BELLINGRATH COUNTRY CLUB ESTATES SUBDIVISION, WILLARD DRIVE ADDITION PHASE TWO

The purpose of this application is to resubdivide 4 existing lots of record, creating common areas at the sides or rear of the lots to accommodate drainage easements and floodplain areas. This common area comprises the portions of the existing lots located in the AE floodplain. The boundaries of the AE floodplain were amended by a Letter of Map Revision (LOMR) dated January 27, 2005. As a result of the subdivision, none of the lots will be located in the floodplain; only the common area will.

DETAIL SITE PLAN

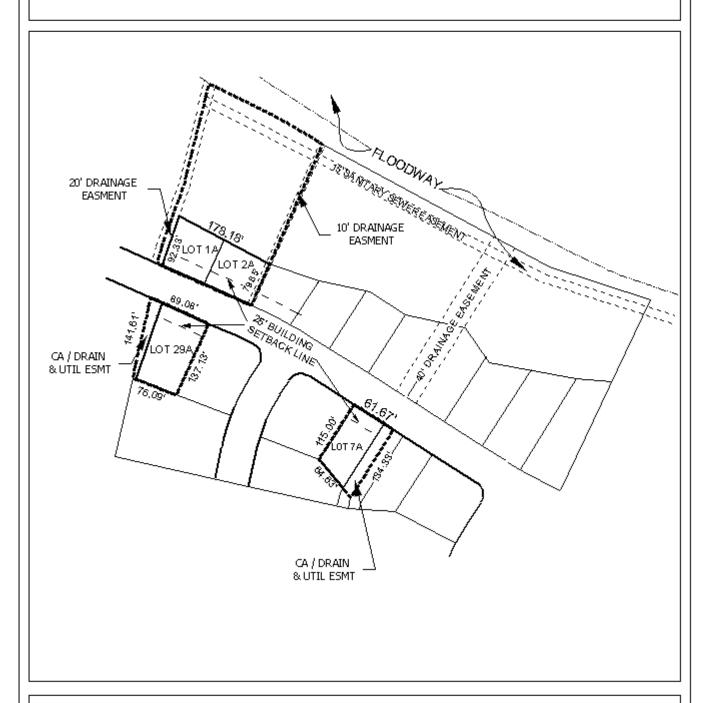
The plat shows the bearings and dimensions of the proposed lots, but neglects to provide any boundary information for the proposed common areas. The plat should be revised so that the boundaries of both the lots and common areas are defined by bearings and distances.

- 1) revision of the plat to additionally show bearings and distance measurements to define the common areas:
- 2) revision of the plat to label each lot with its size in square feet, or placement of a table on the plat with the same information;
